Evaluation of Ecological Impact Assessment (EcIA) and BNG
Habitat Management & Monitoring Plan (BNG/HMMP)
Land North of Colwell Farm, Haywards Heath

EcIA & BNG/HMMP Analysis

Photo 1: Field 2 in March 2025

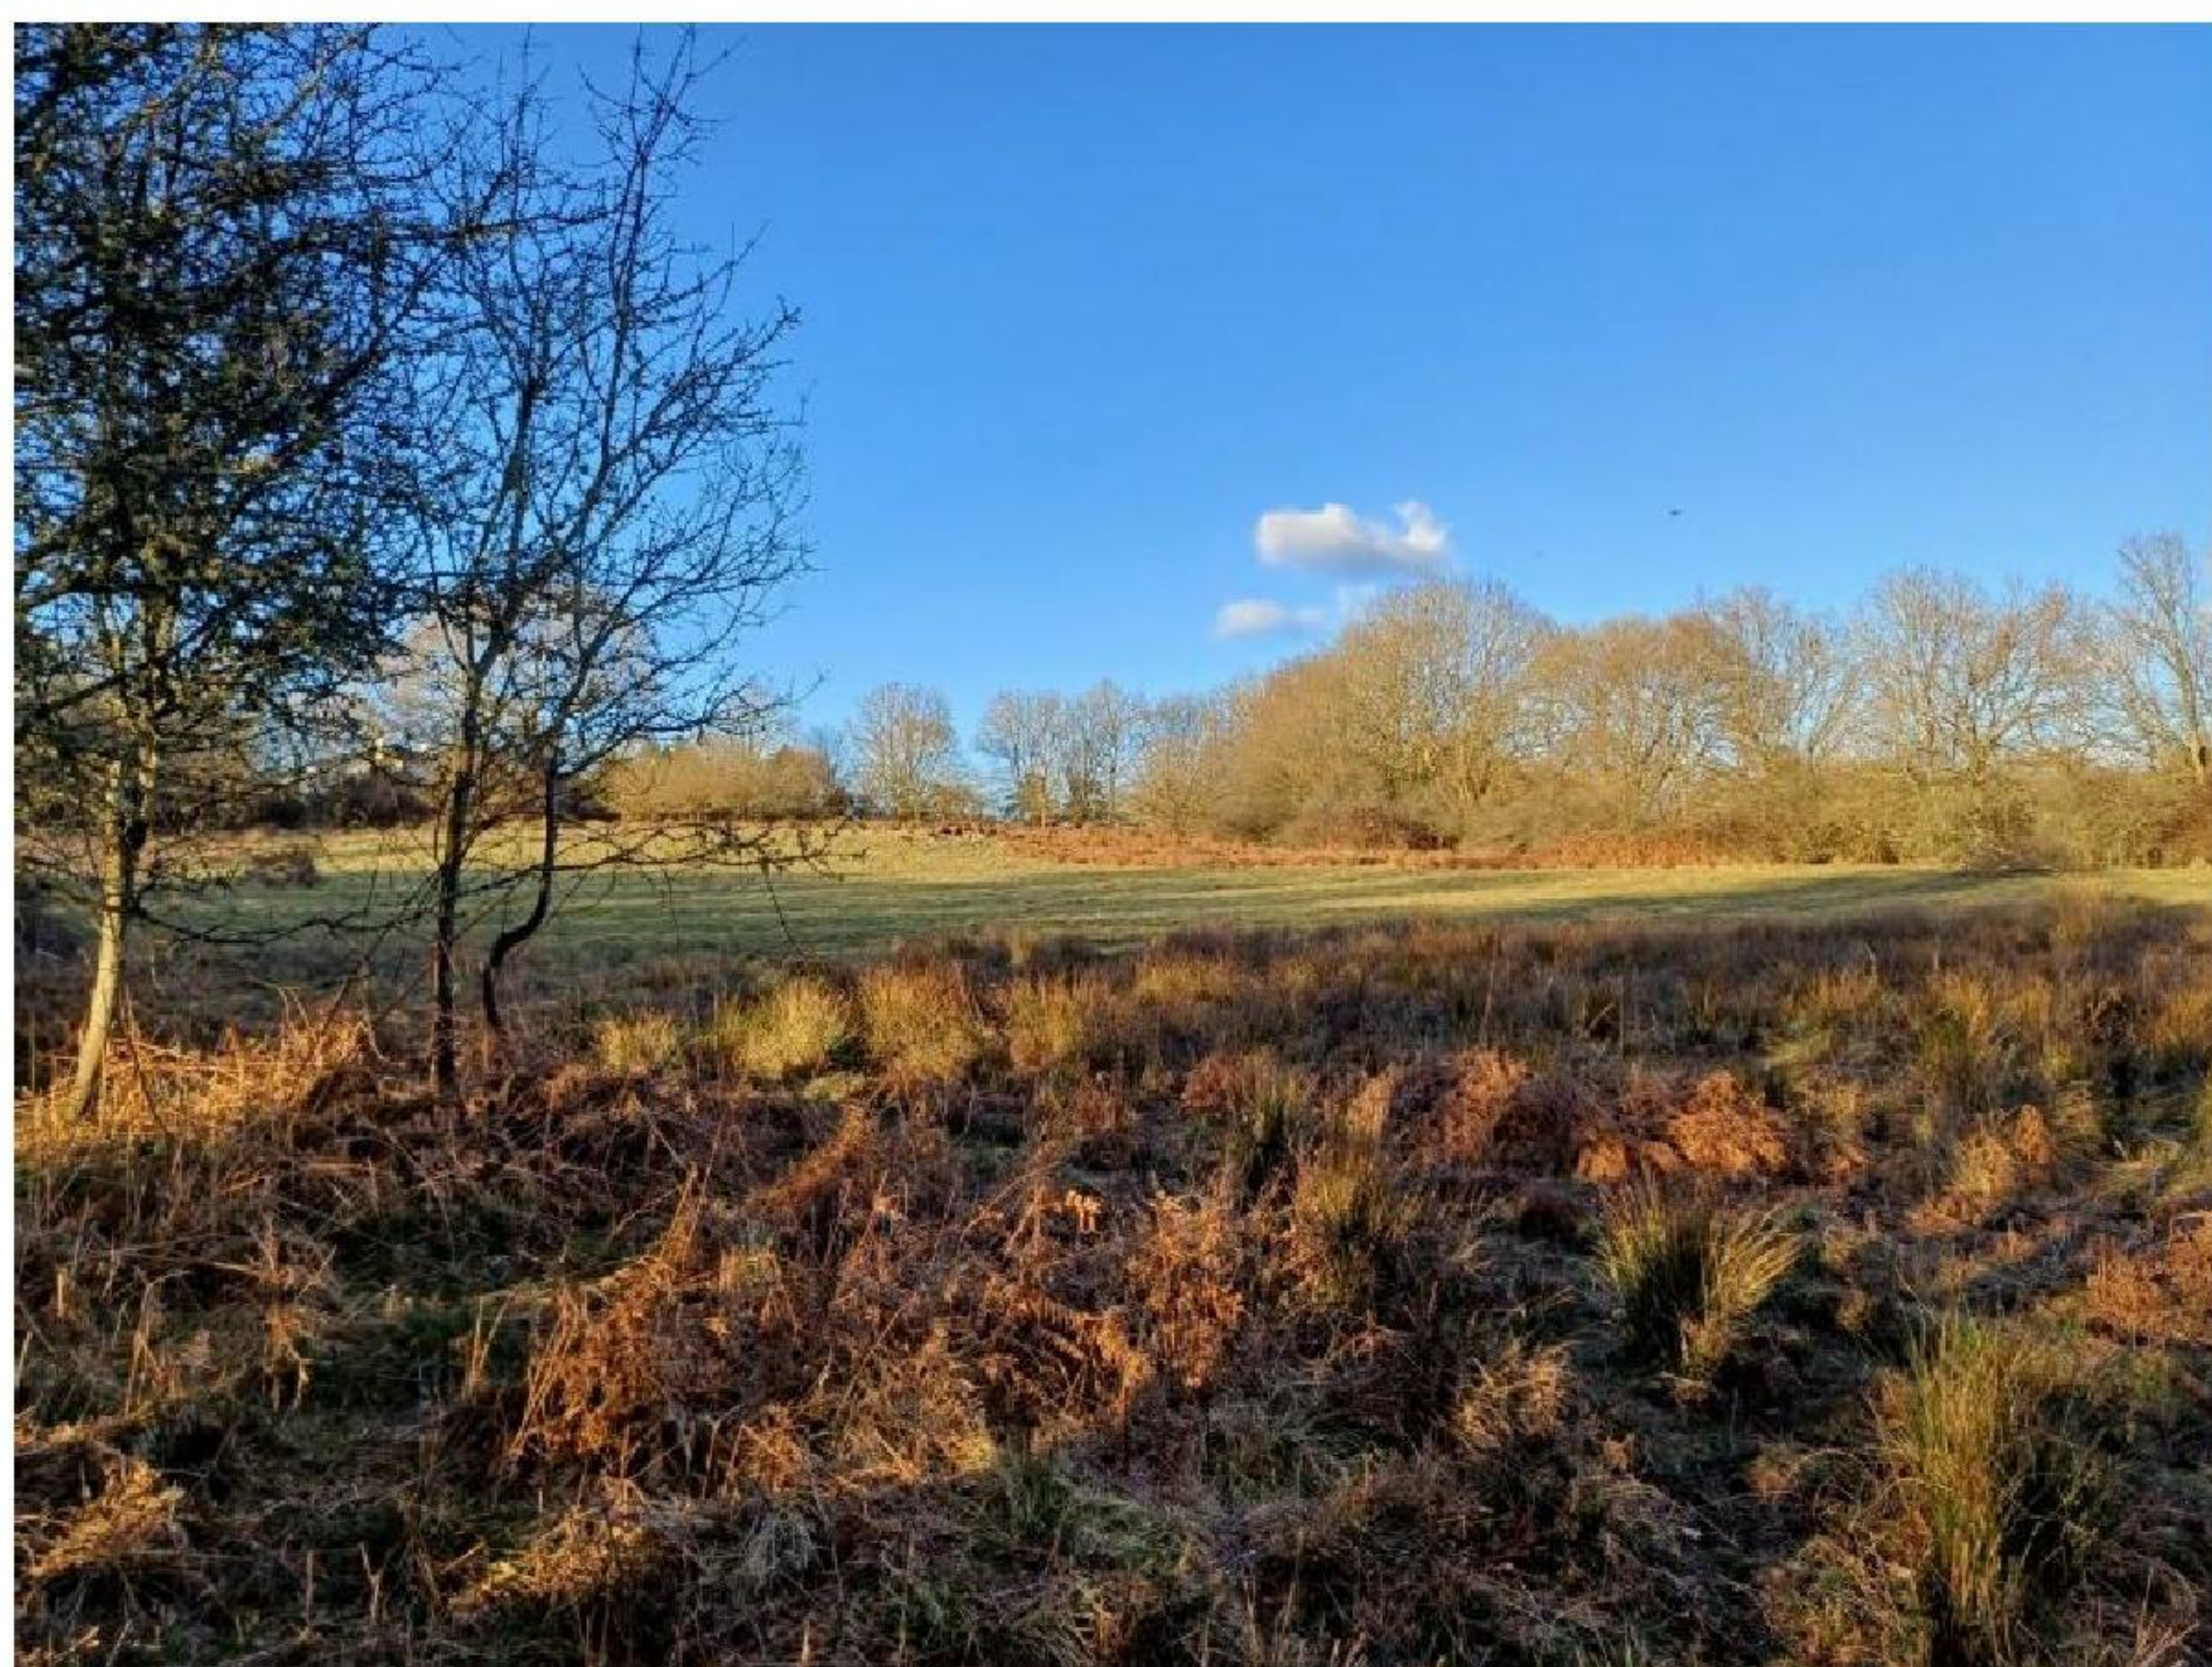
The plant diversity of the site cannot be illustrated, as the developers have omitted this information for the report.

A full plant list, along with abundance information, should have been provided in either the EclA or BNG/HMMP. Omission of this, does not meet CIEEM's Guidelines for Preliminary Ecological Appraisal¹. According to these guidelines, a habitat survey should include *"descriptions of plant species present and their abundance"*.

Figure 1 : Lighting Strategy (Land at Colwell Farm Haywards Heath)

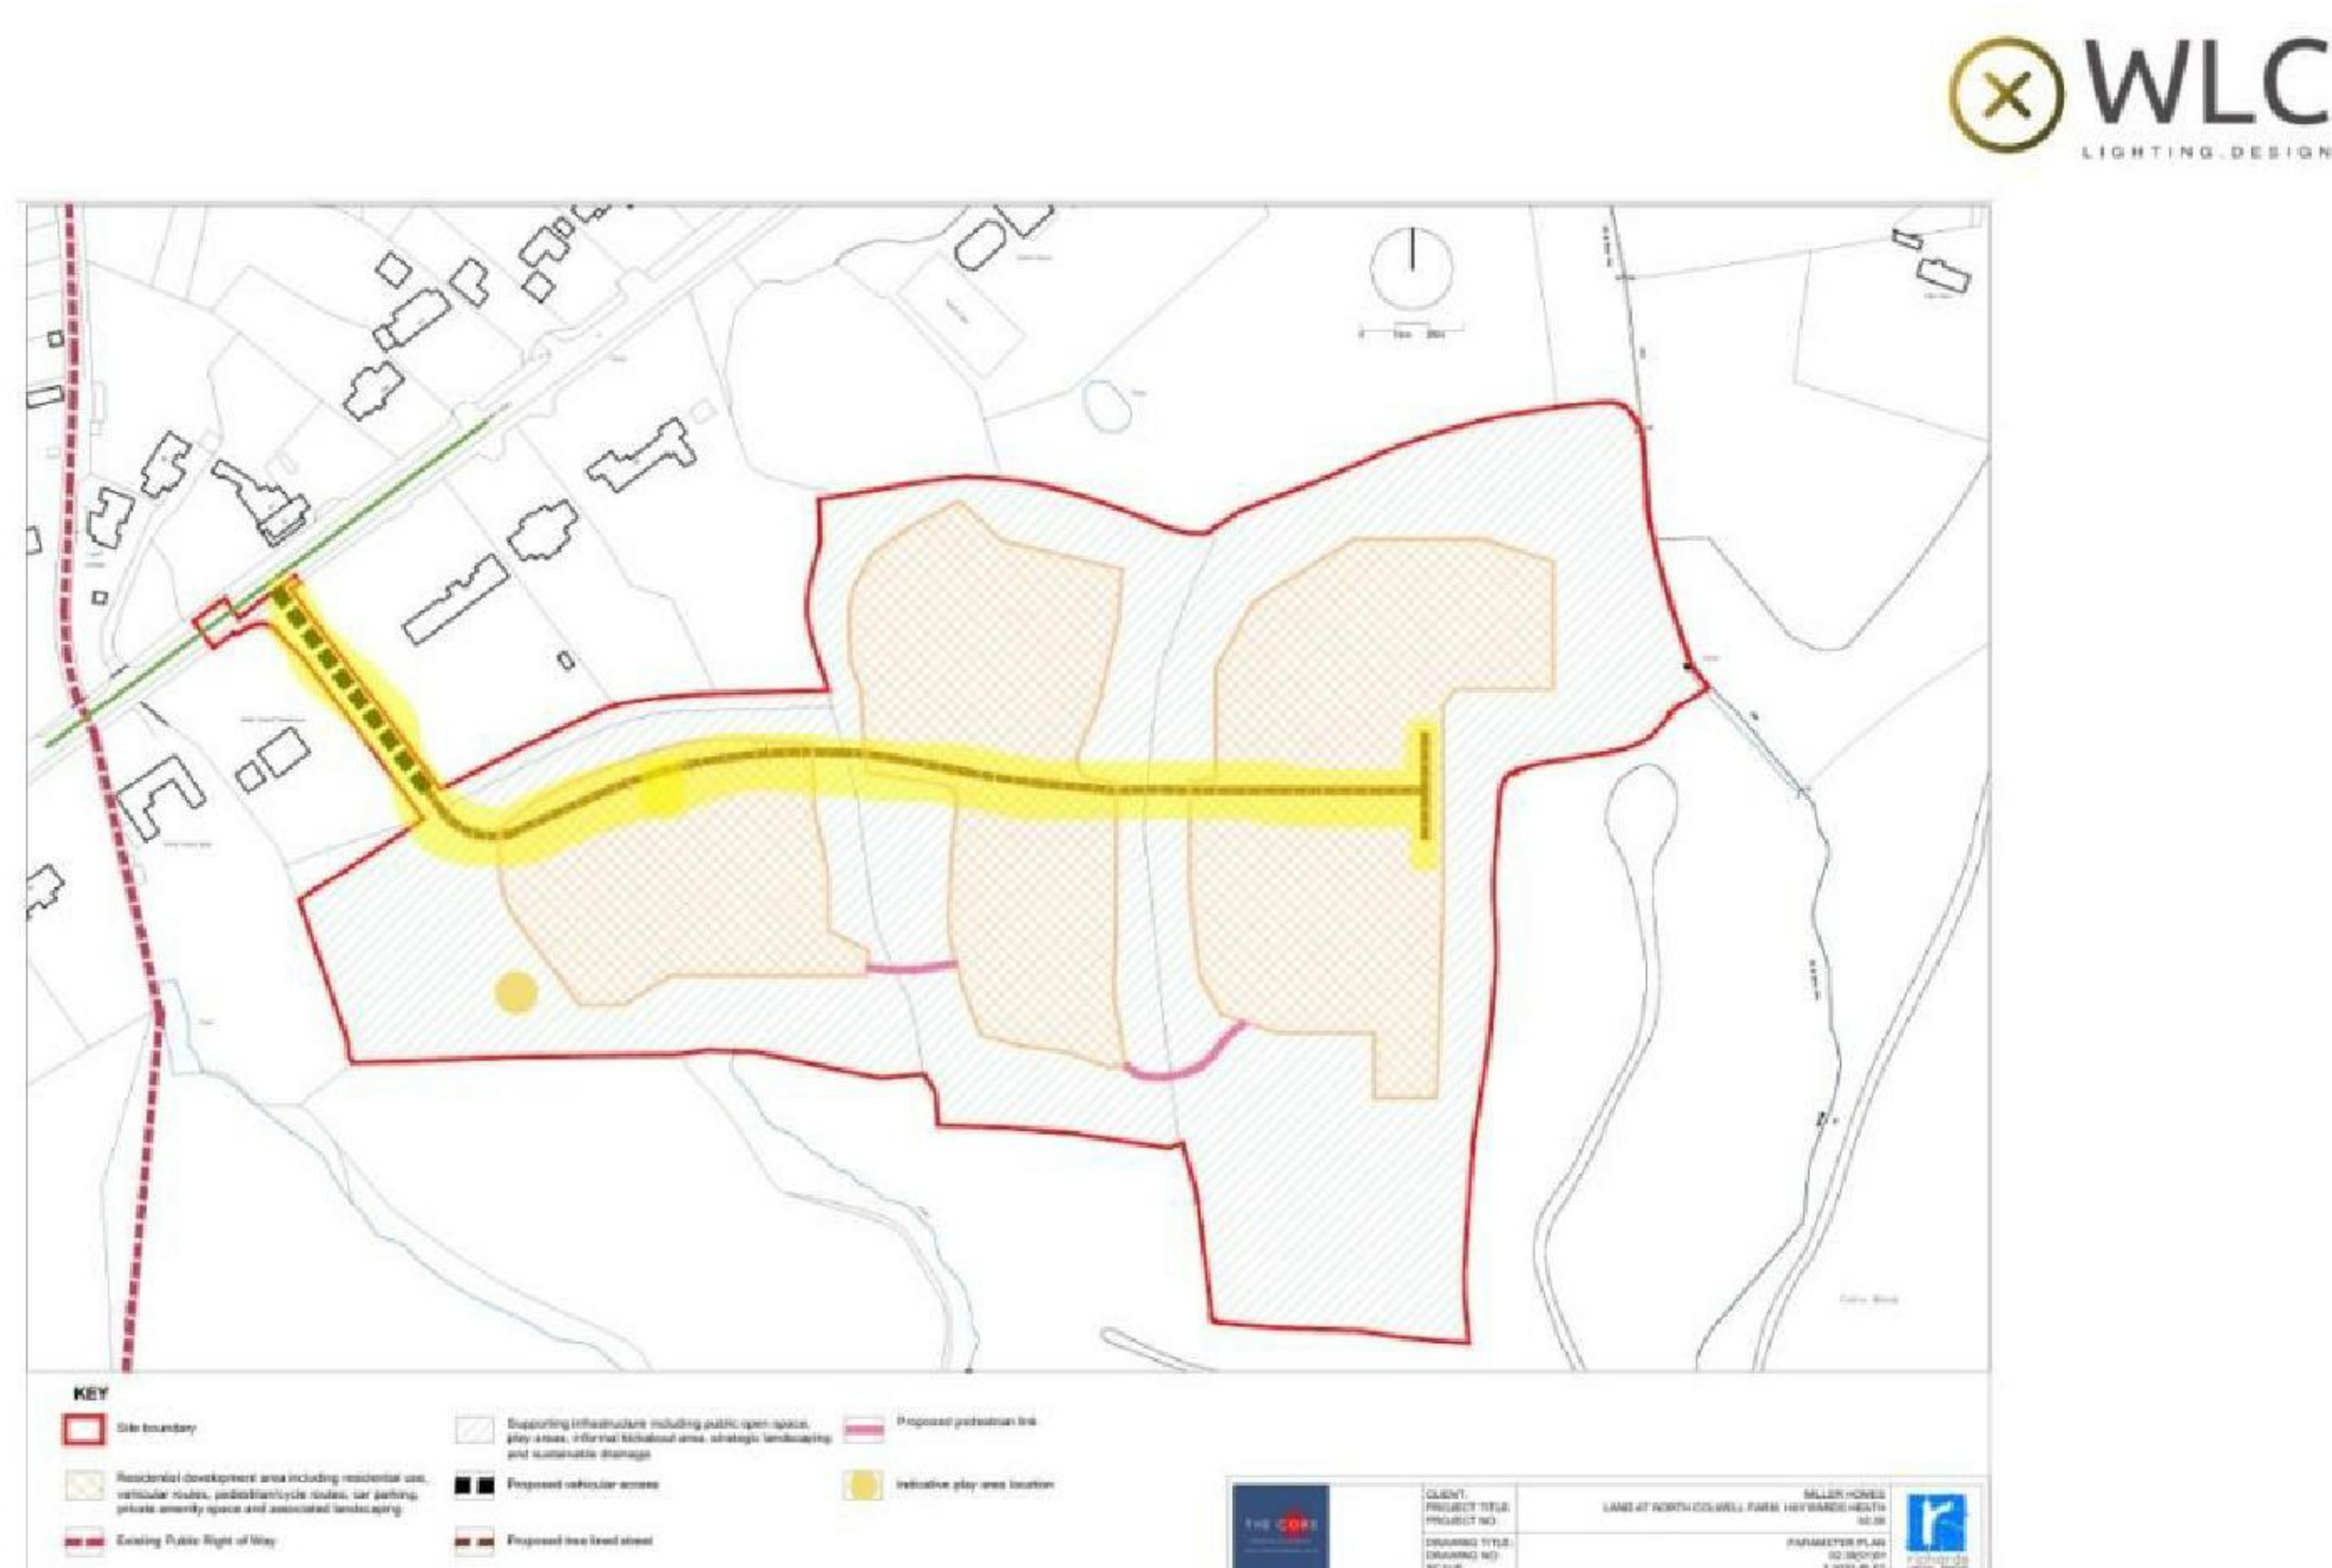
This statement and map contradicts to Millers Homes' statement and map in the Lighting Strategy, prepared by WLC Lighting Design and submitted by the developer in support of their proposal for Land at North Colwell Farm.

WLC proposes Lighting Levels for street lighting that are minimum average 3 lux, maximum average 5 lux (Table 2). The developer includes the following map in the Lighting Strategy, which contradicts Figure 27 in the EclA.

In addition, in the Lighting Strategy, the developer proposes a “pre-curfew” lighting of 10 Lux and a “post-curfew” lighting of 2 lux. They do not explain at what time the post-curfew lighting starts.

Image 4: Photo taken from Field 2 towards Field 1 showing destruction of hedge (February 2025)

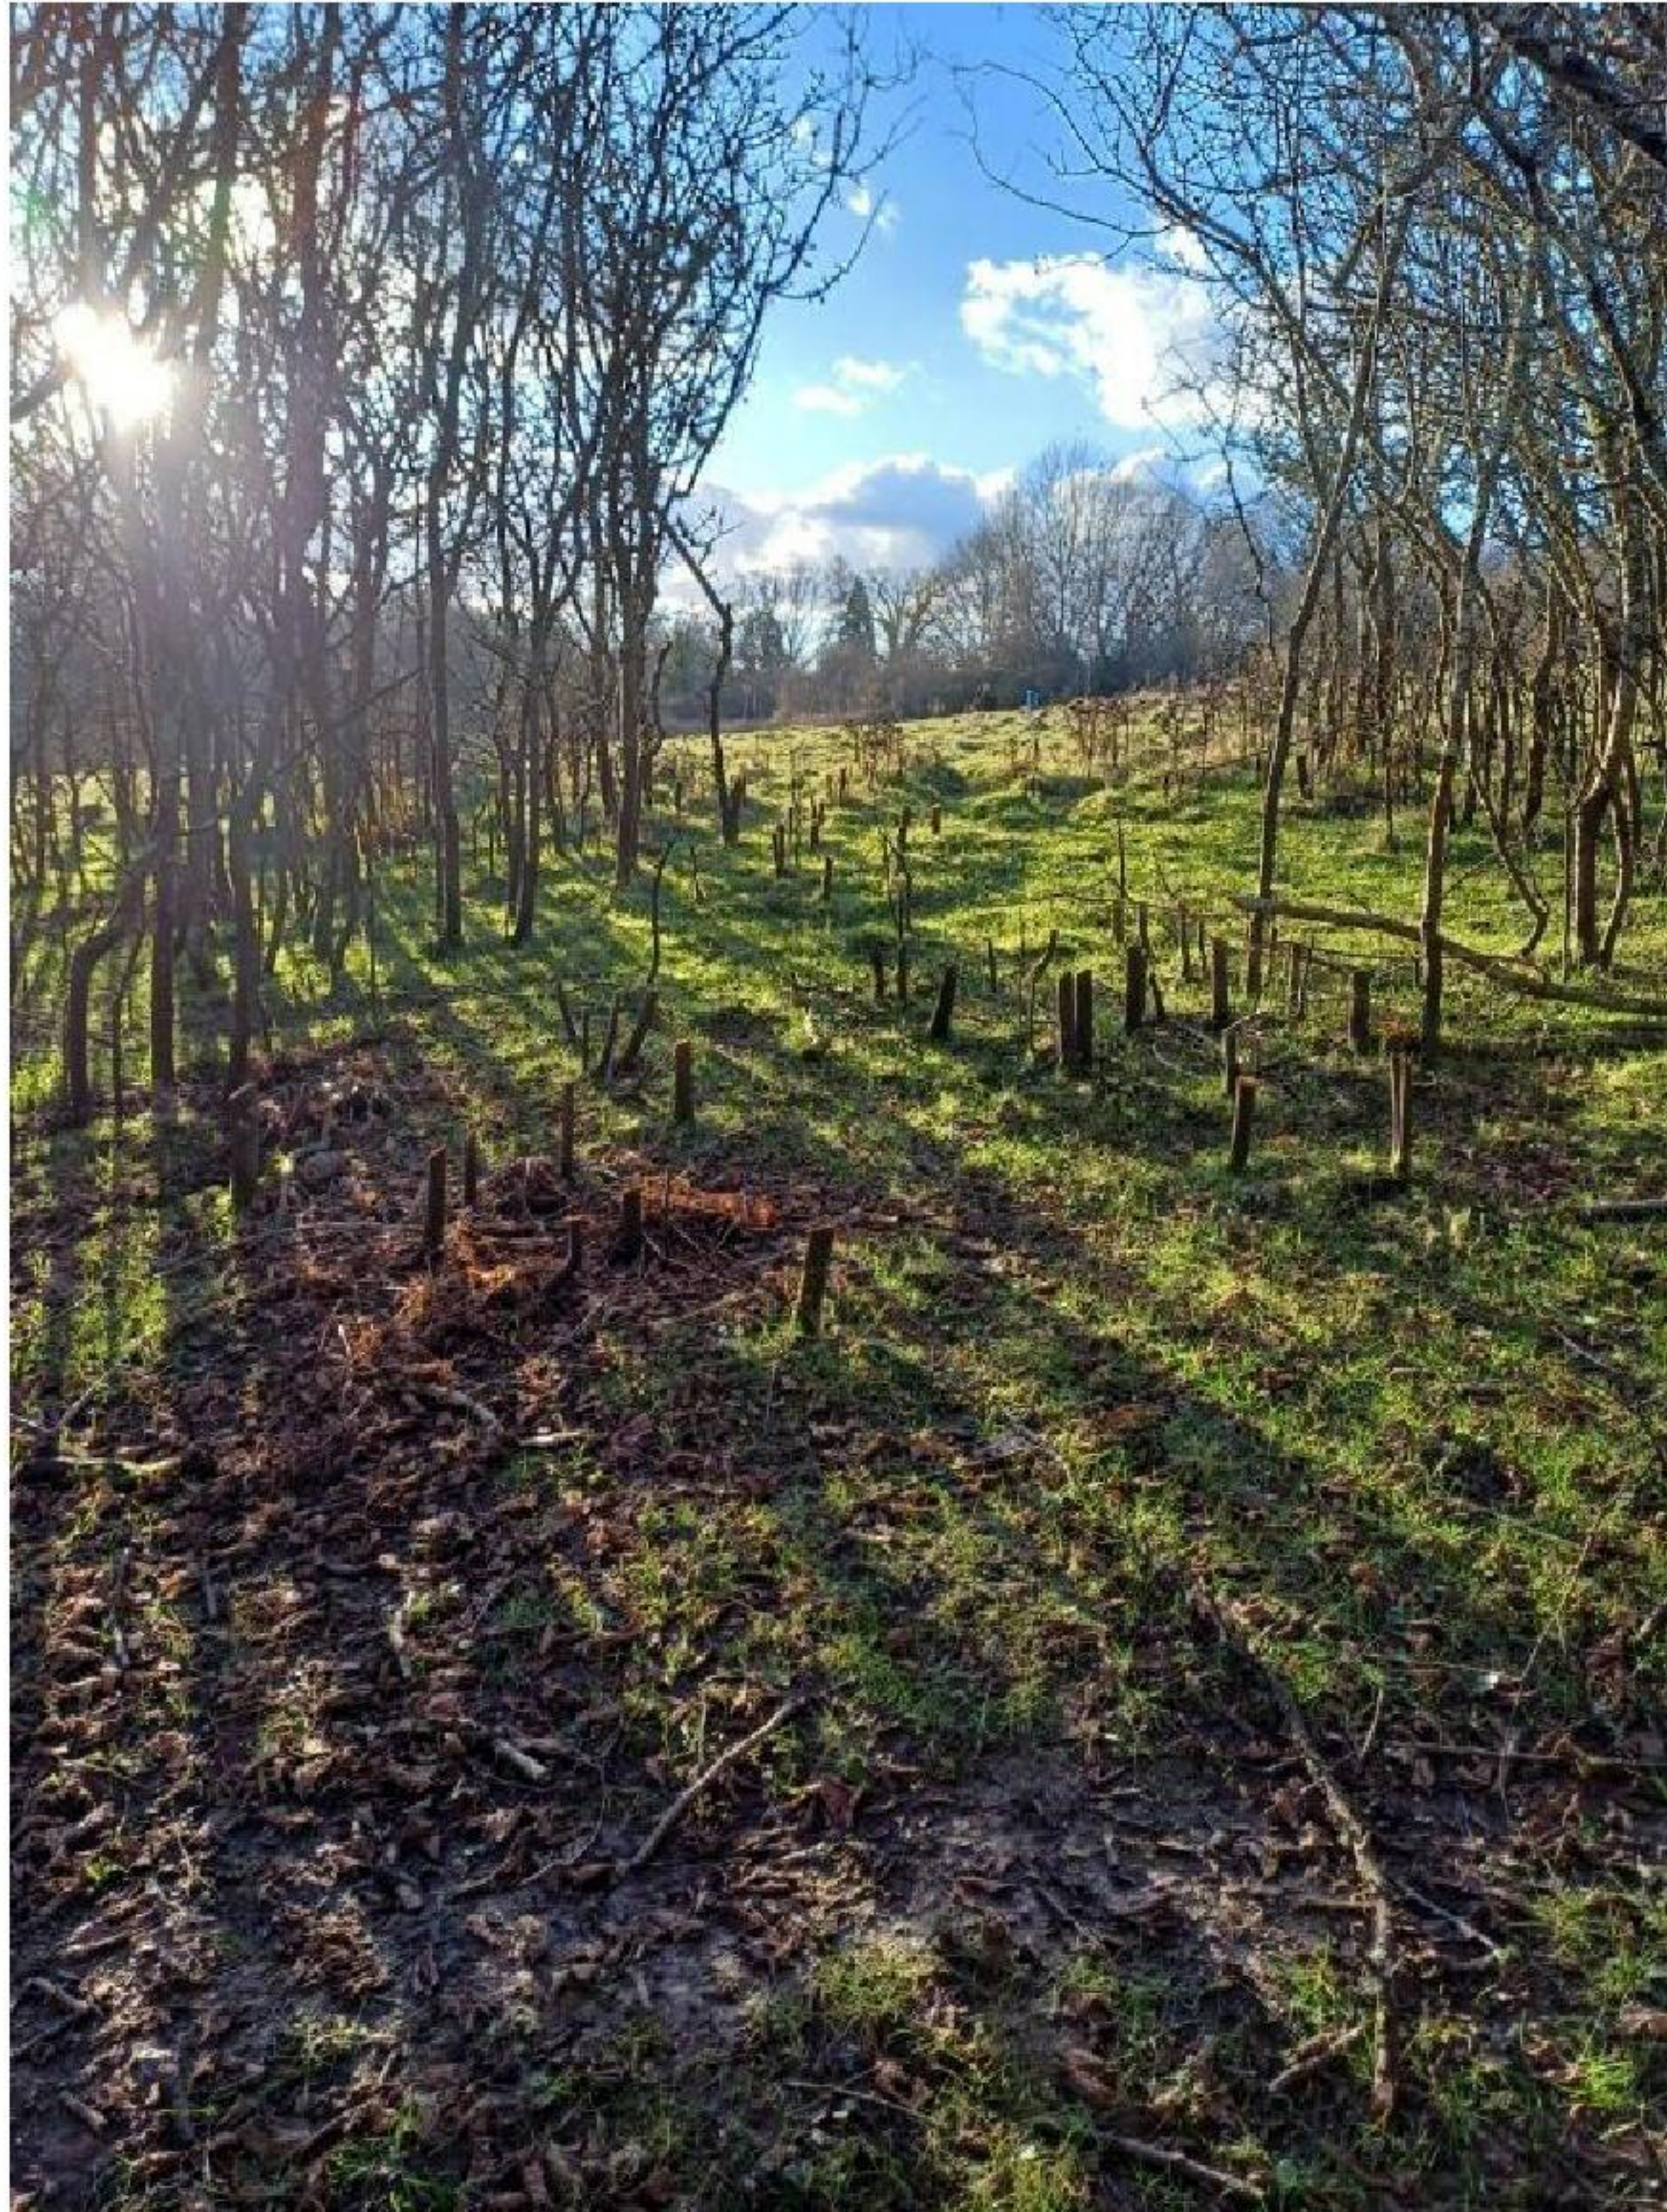
- Hedges and Bramble scrub adjacent to Dormouse locations removed by Millers Homes in Winter 2024, without following its proposed mitigation strategies
